FITZSIMONS GATEWAY MULTIFAMILY | SITE PLAN

AMENDMENTS

12100 E COLFAX AVE
AURORA, COLORADO

DATE:
08/24/22 - SITE PLAN 01
10/17/22 - SITE PLAN 02
11/23/22 - SITE PLAN 03
12/19/22 - SITE PLAN 04
02/13/23 - SITE PLAN 05
05/17/23 - MINOR AMD 01-1
12/08/23 - MINOR AMD 01-2
01/30/24 - MINOR AMD 01-3
12/12/24 - MINOR AMD 02-1

SHEET TITLE:
NORTH & EAST ELEVATIONS

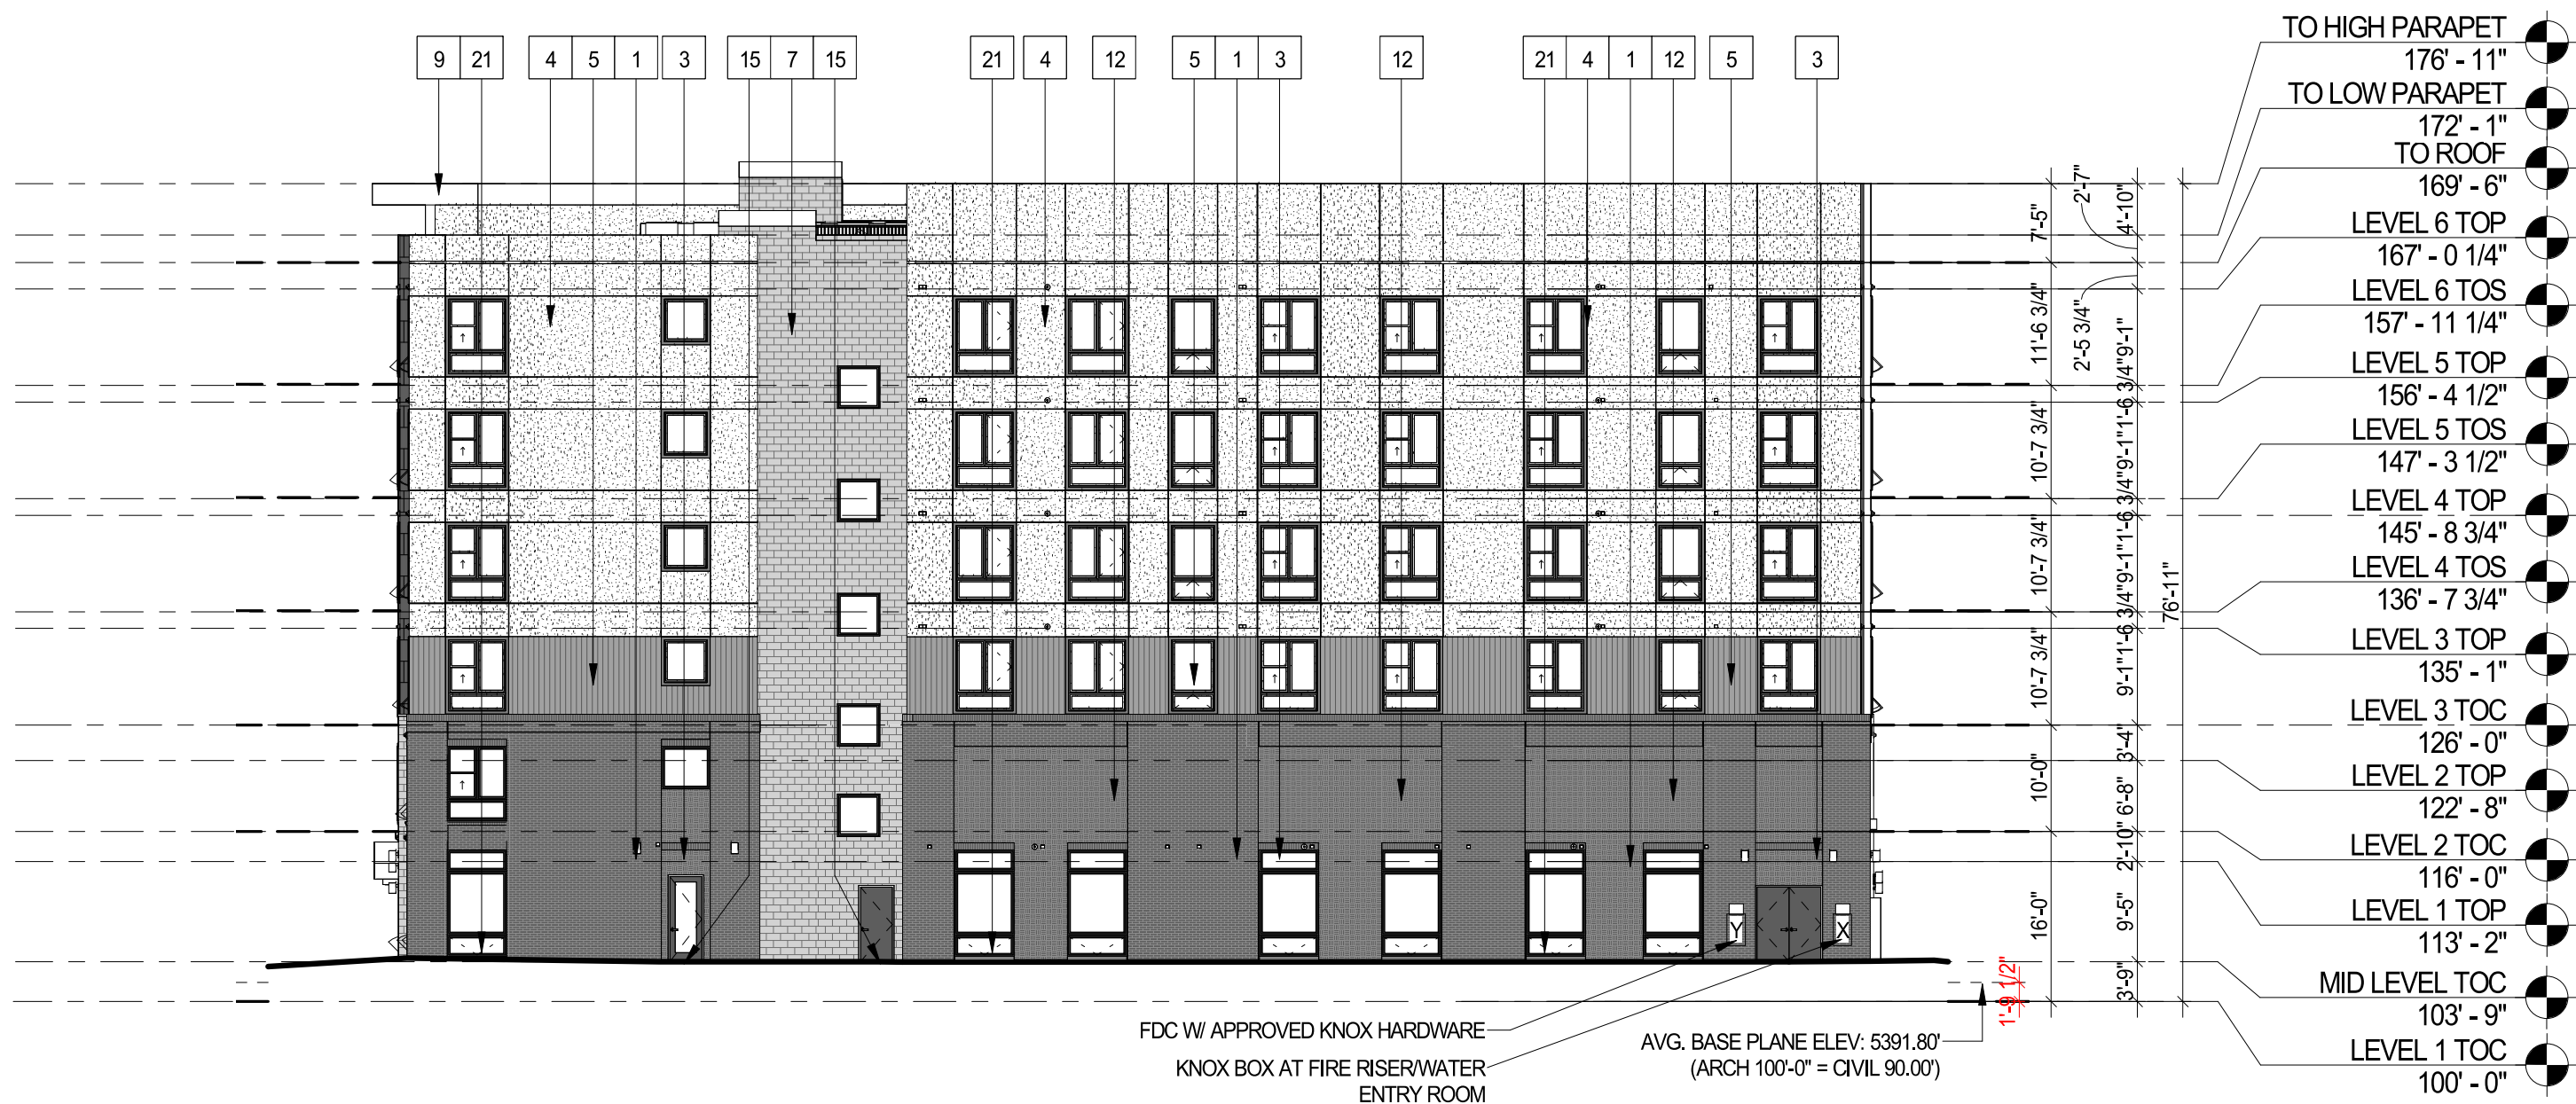
- PORTION OF MESH SCREENING ON EASTERN GARAGE ELEVATION HAS BEEN REMOVED TO PROVIDE INCREASED GARAGE VENTILATION AND REDUCED MESH MATERIAL AREA. UPDATE SHOWN ON EAST ELEVATION.

SHEET TITLE:
OVERALL PLAN -
LEVEL 1 & 2

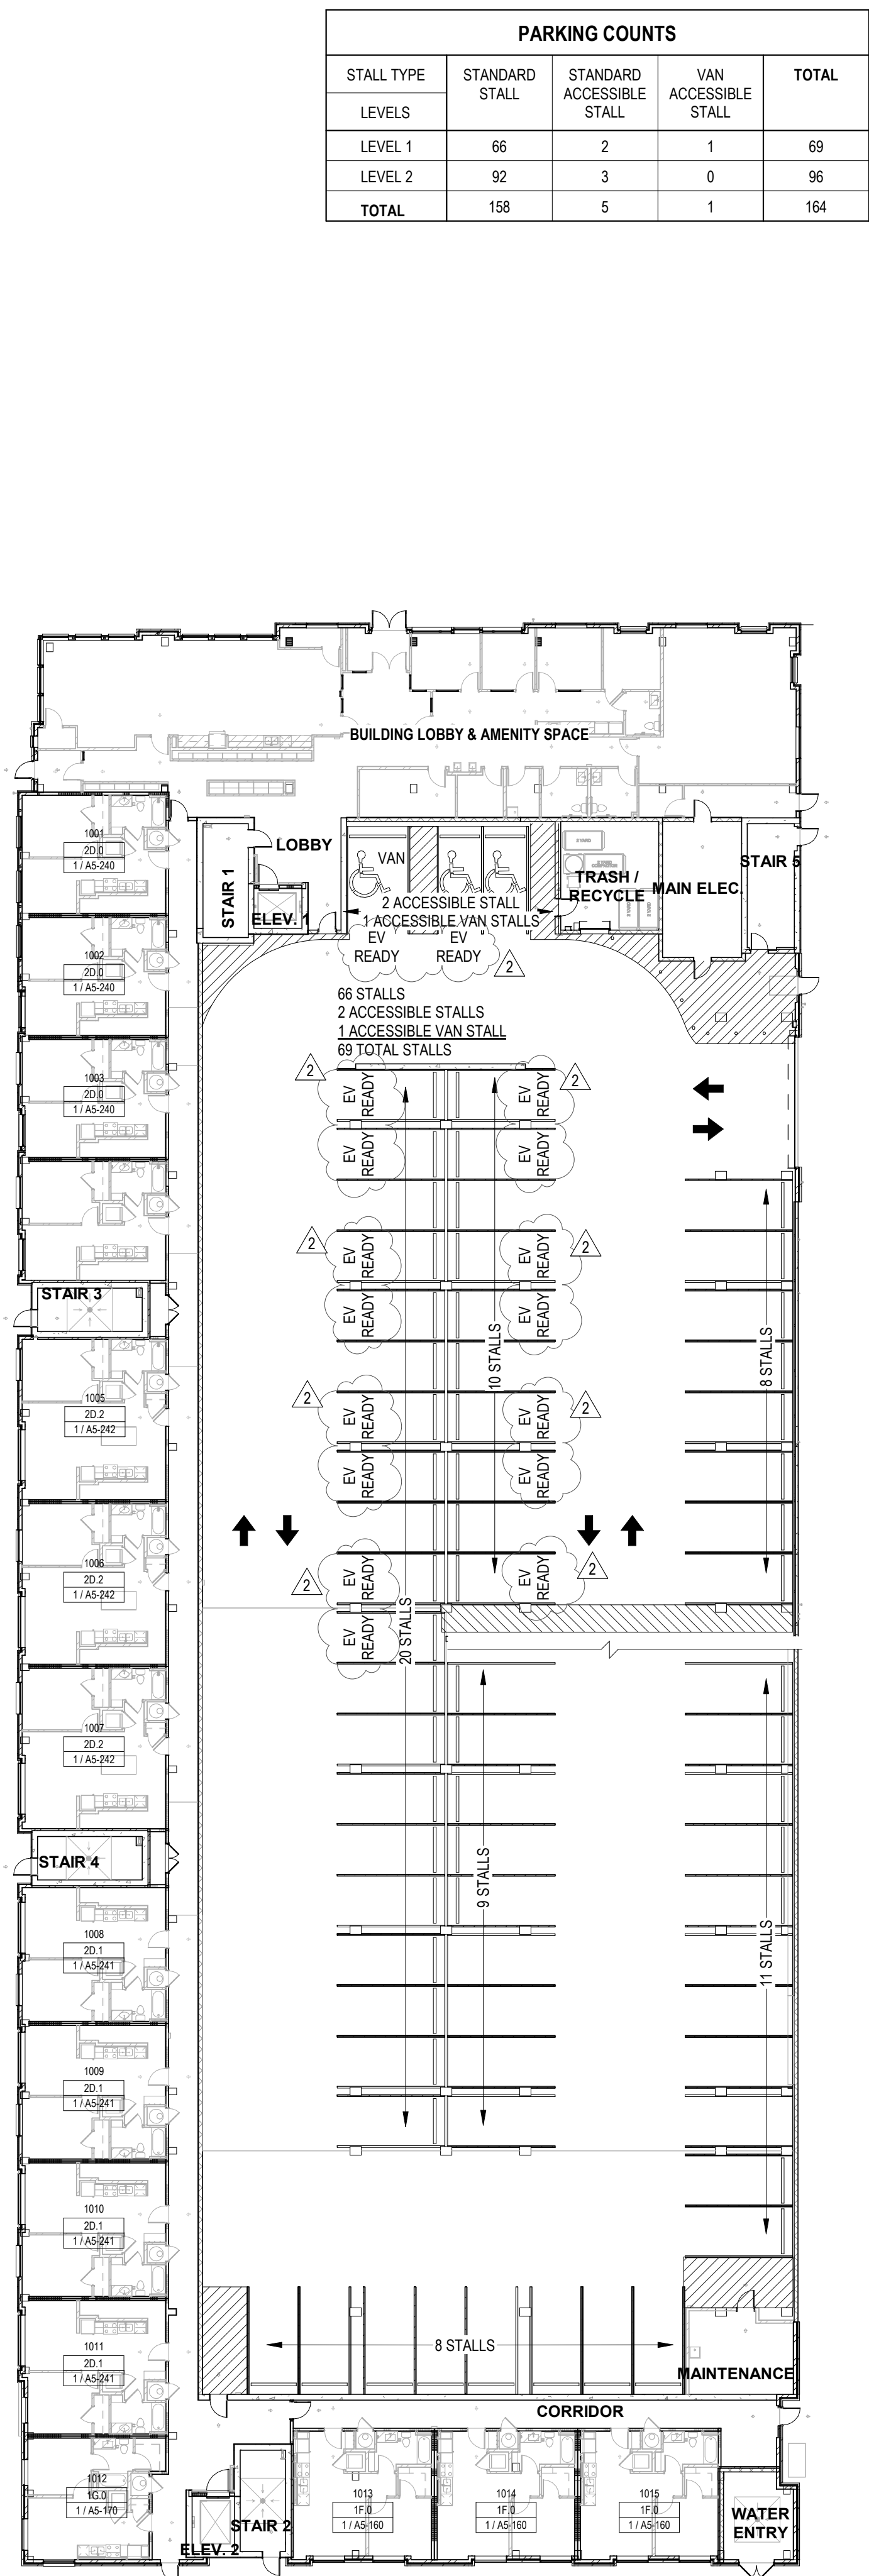
- LEVEL 2 UPDATED TO SHOW CHANGE IN LOCATION OF MECHANICAL WALL VENT, NOW MIRRORING THE SYSTEM IN THE ADJACENT ROOM.
- LEVEL 1 FLOOR PLAN UPDATED TO SHOW EV-READY STALL LOCATIONS

LEVEL 3
PHOTOMETRIC

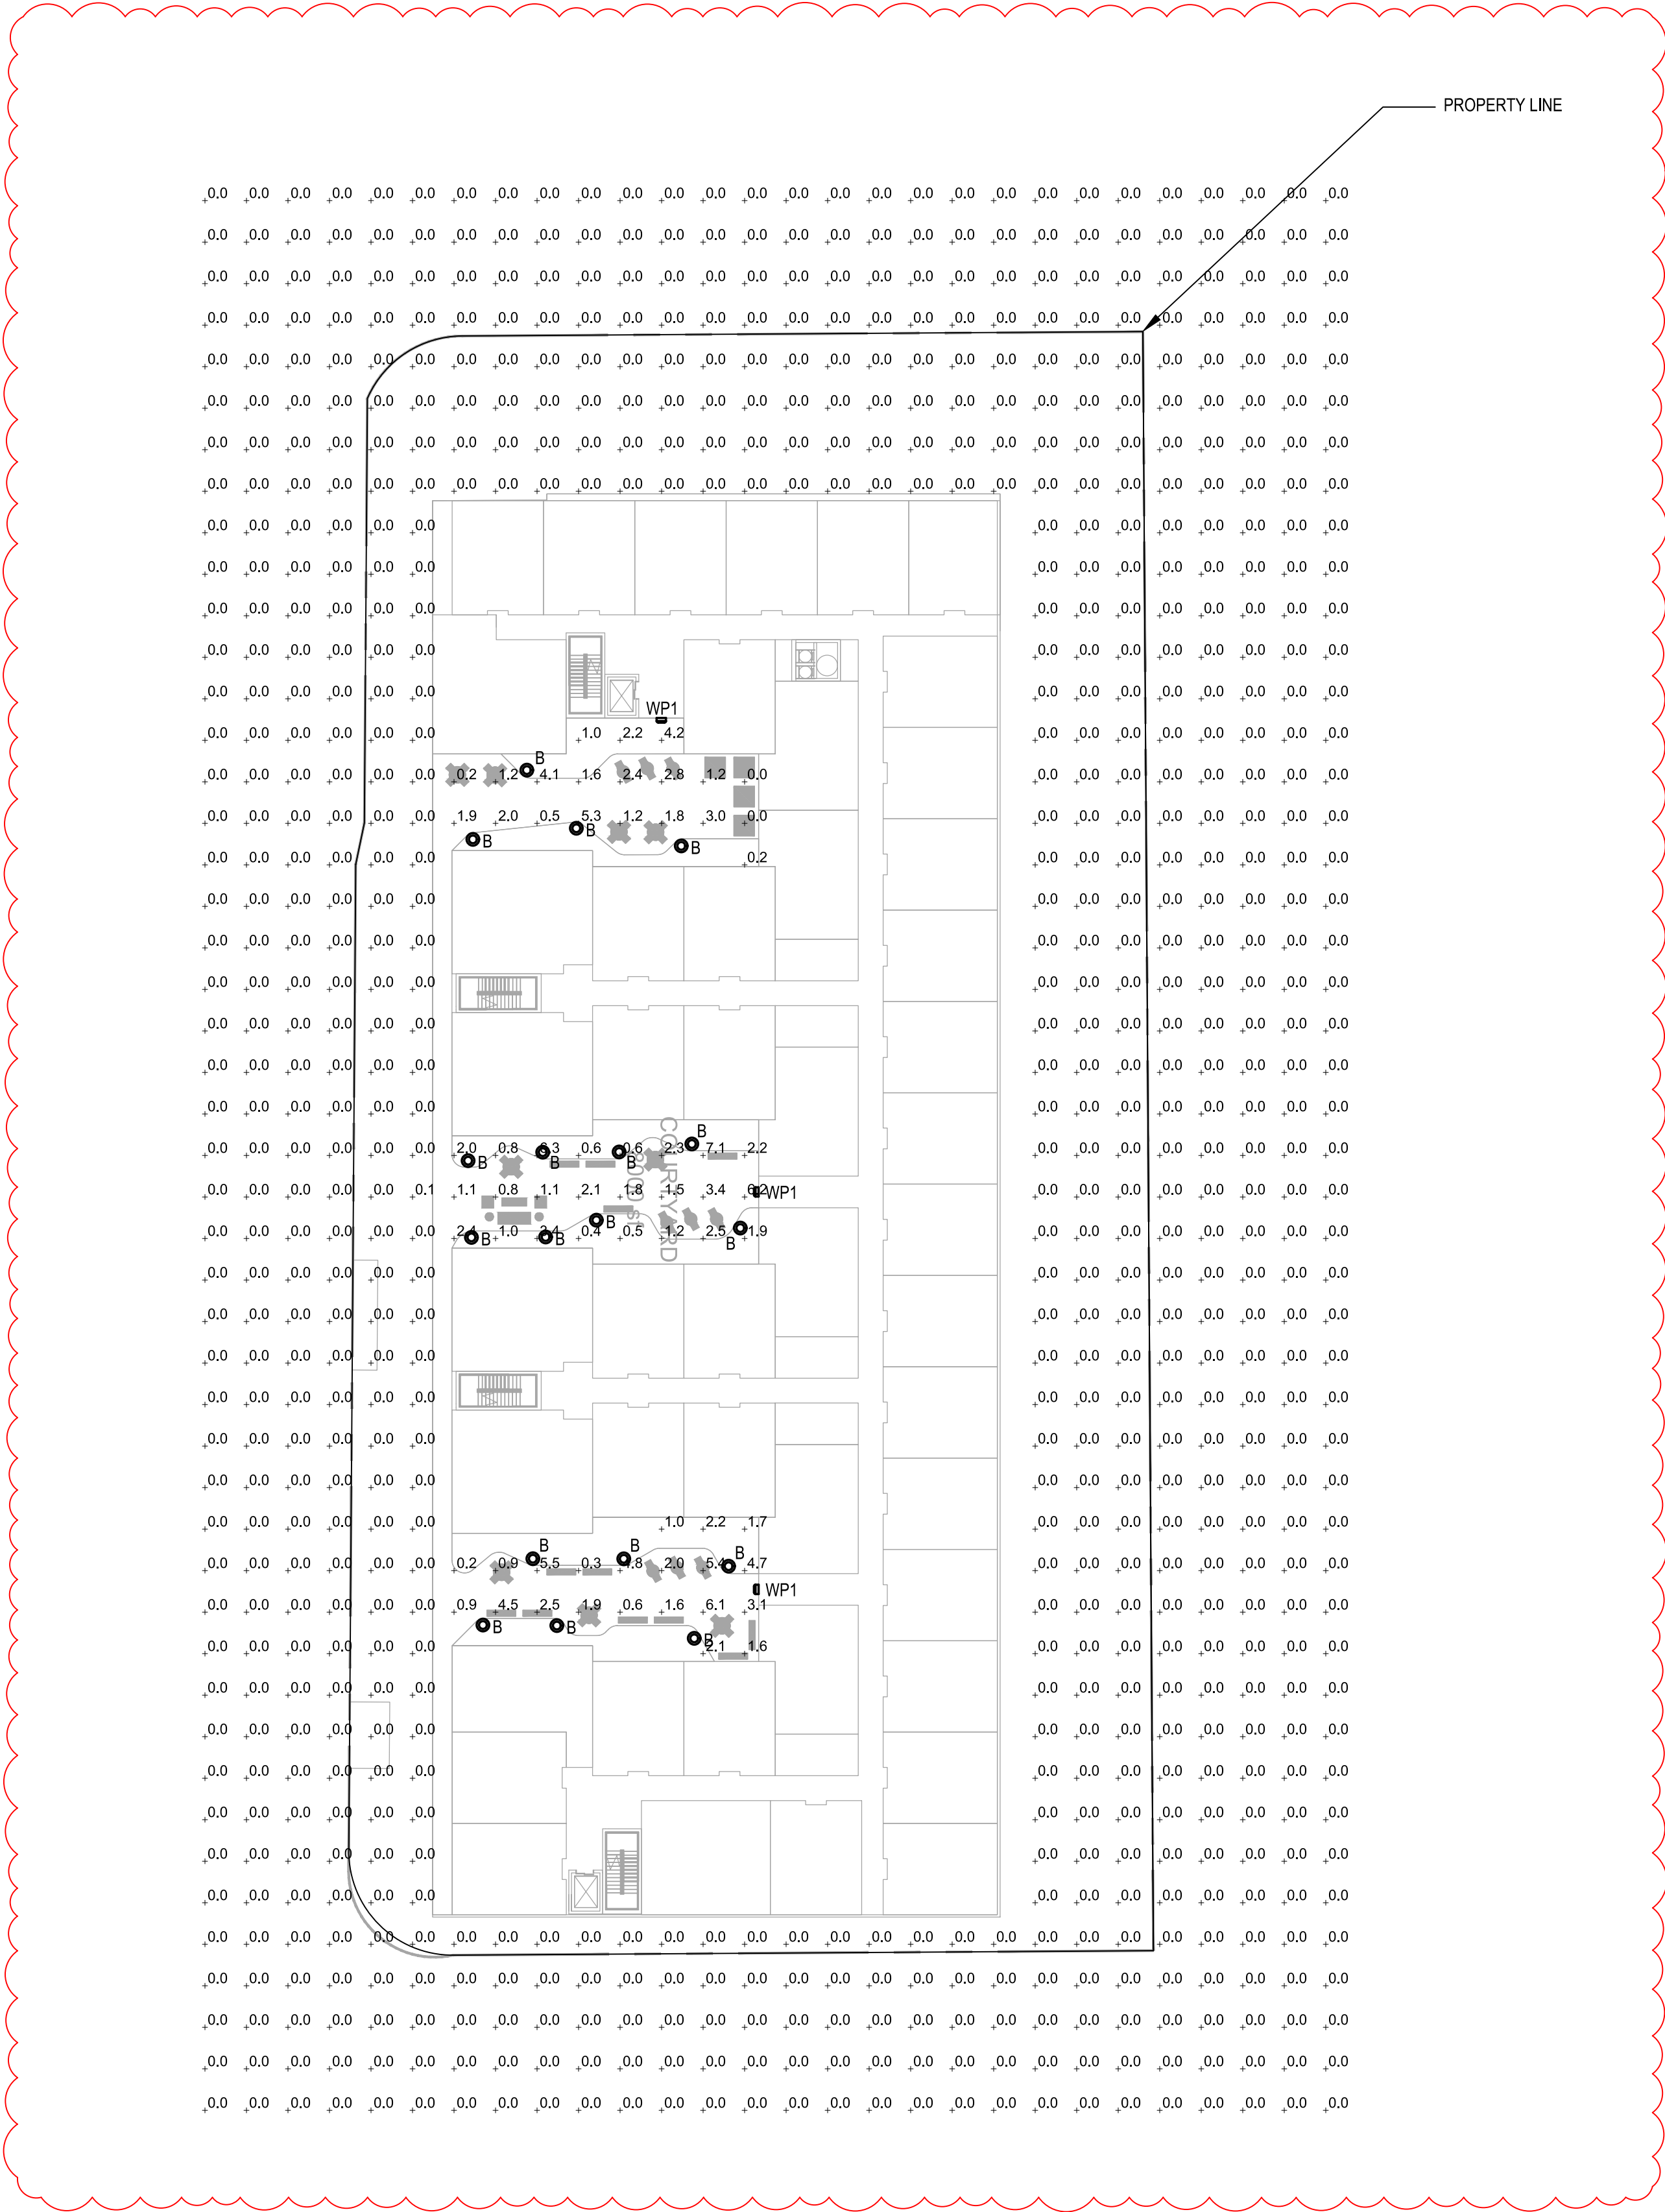
2
LIGHTING PLAN HAS NOT CHANGED. SOME FIXTURE
SPECIFICATIONS REVISED.
